# Craig y Perthi Solar Farm

### Appendix 1.1 Newport City Council Pre-Application Response

**PROPOSAL:** PRE-APPLICATION PLANNING ENQUIRY FOR A PROPOSED SOLAR FARM, BATTERY STORAGE, WILDLIFE ENHANCEMENT AREA AND ANCILLARY DEVELOPMENT

**SITE:** Land south of Castle Farm, Bishton, Newport

## CNC/NRW Development Advice Map, Accessed (31.01.2022)

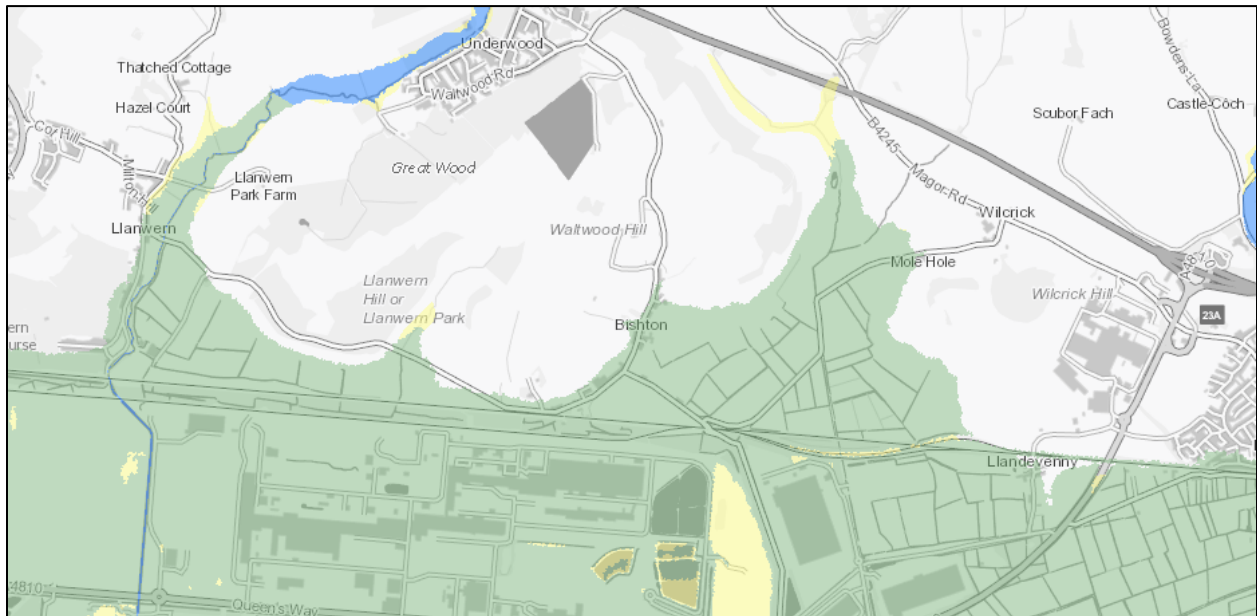
Significant parts of the site lie in areas within defended floodplains, green on the plan extract below. These include areas identified for solar arrays and for the sub-station.

The position regarding the substation / grid connection yard (battery storage area?) is more opaque and could be classed as highly vulnerable development (power stations). Some consideration should be given to this issue in any submitted application.

In terms of run-off the site will remain primarily grassed and the impacts of run-off from the panels should be minimal. However any areas of significant hard standing such as access tracks and the grid yard may need some attenuation measures and consideration of run-off and means to deal with it should form part of any submission.

In terms of general reen maintenance corridors should be left at least 7m wide along minor reens and 12m along major reens to allow machine access for cleaning purposes given the long lifetime of the development proposed.

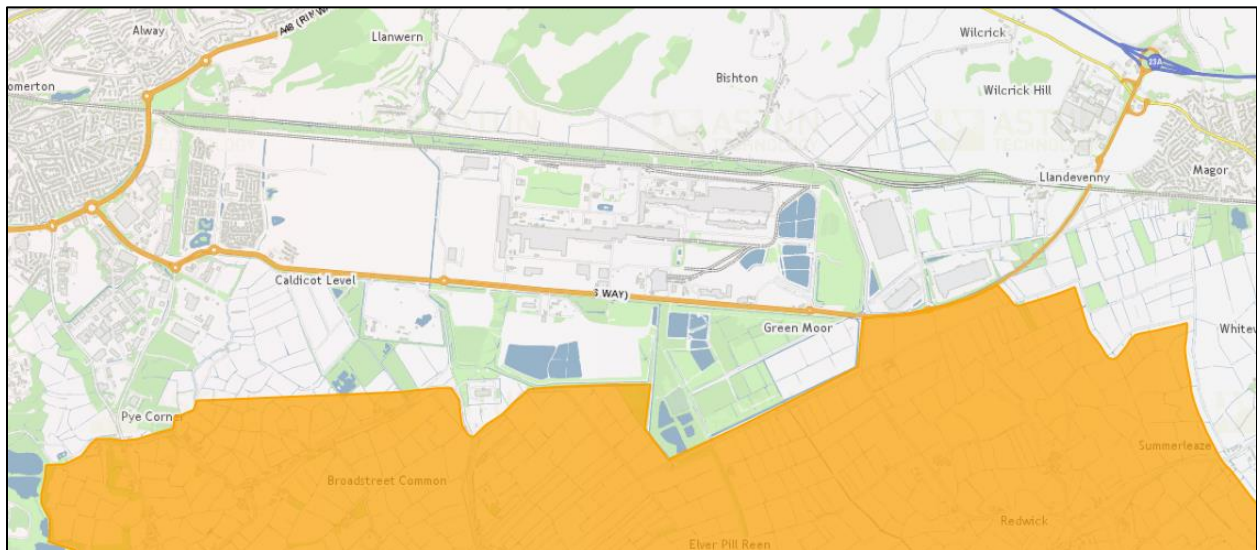
I would suggest some consideration is given to long views from the seawall over the Gwent Levels Special landscape Area from the All Wales Coastal Path and the likely impact on amenity of users of that important route.

## Archaeologically Sensitive Area (iShare extract)

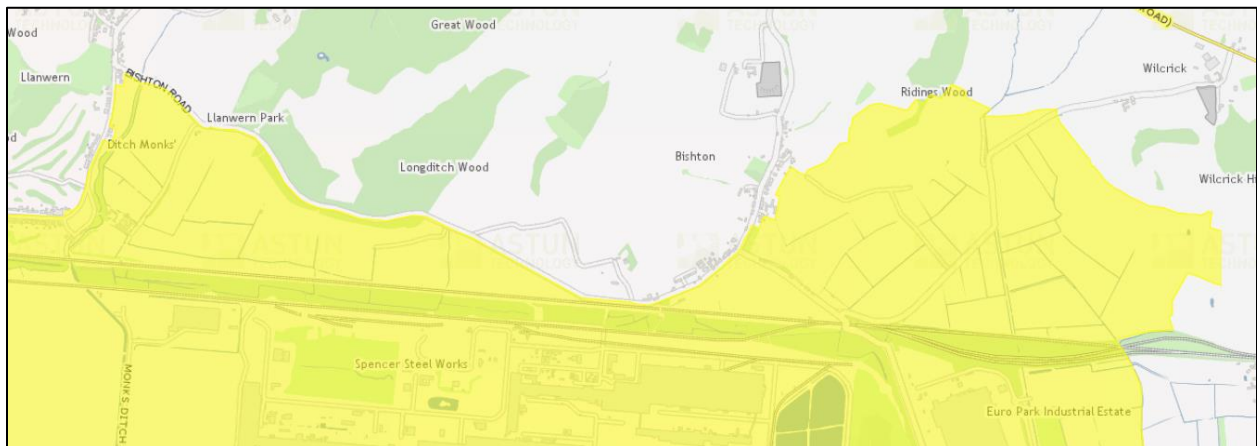
The Levels parts of the site fall within an Archaeologically Sensitive Area. The generally high water tables in these locales leads to anaerobic conditions and high levels of preservation of organic material. There is a strong likelihood of preserved archaeology in these areas.

The banks of former pills (river courses) now lost under the reclaimed moors can be particularly rich in archaeological terms and ideally these should be identified due to their greater potential for archaeology.

An assessment for the potential of the scheme to impact on below ground archaeology and how that might be mitigated should be provided in my view.

Llanwern Park – Historic Park & Garden & Bishton Castle Scheduled Monument (iShare Extract)

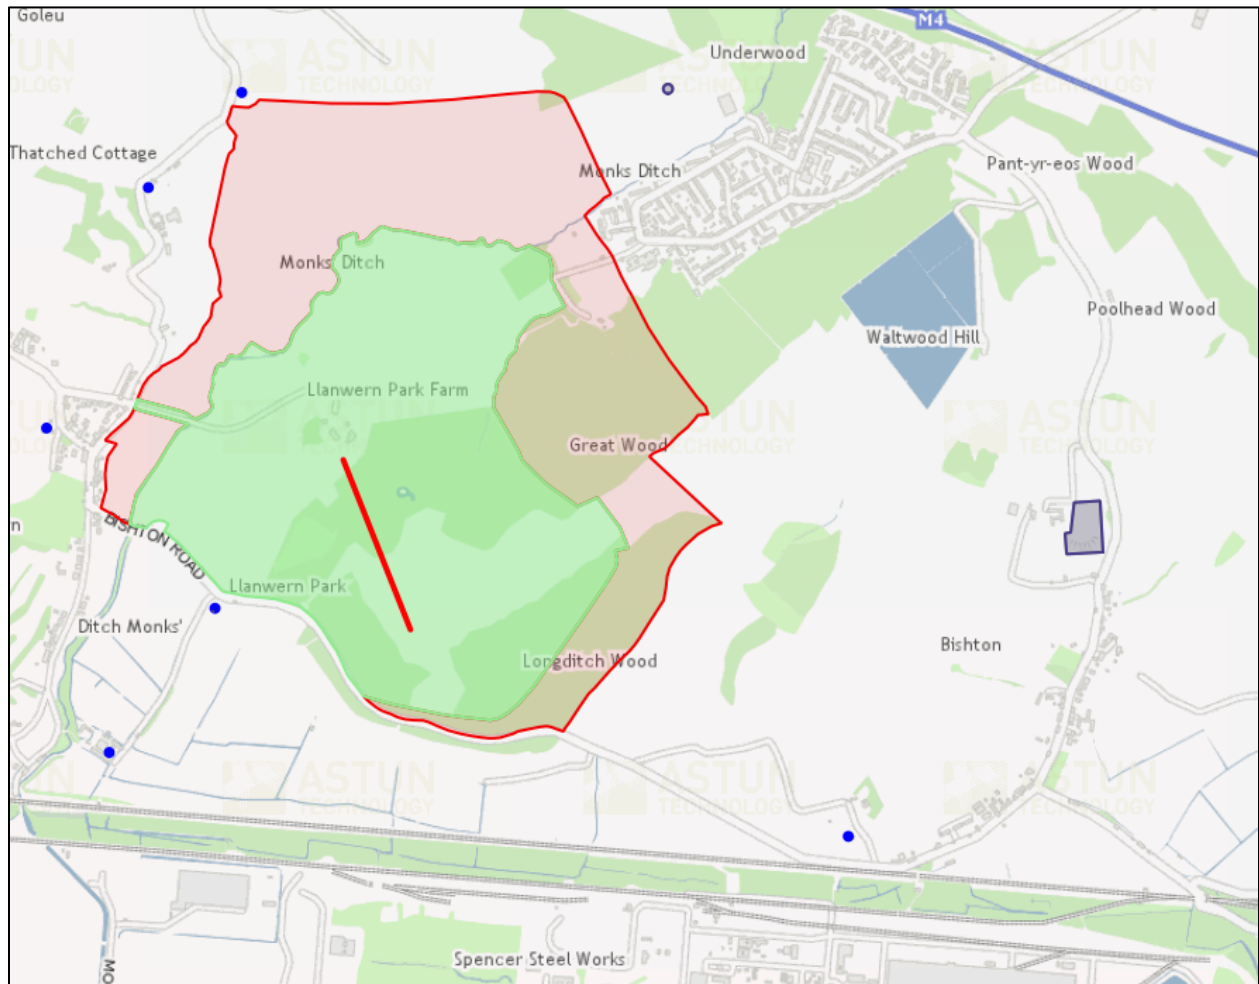
The proposal will have direct impact on the Park and will affect key views of the site, note dark red line on the plan extract above. All of these should be carefully assessed.

The proposal will impact on the setting the Bishton Castle Scheduled Monument (MM128). This should be assessed.
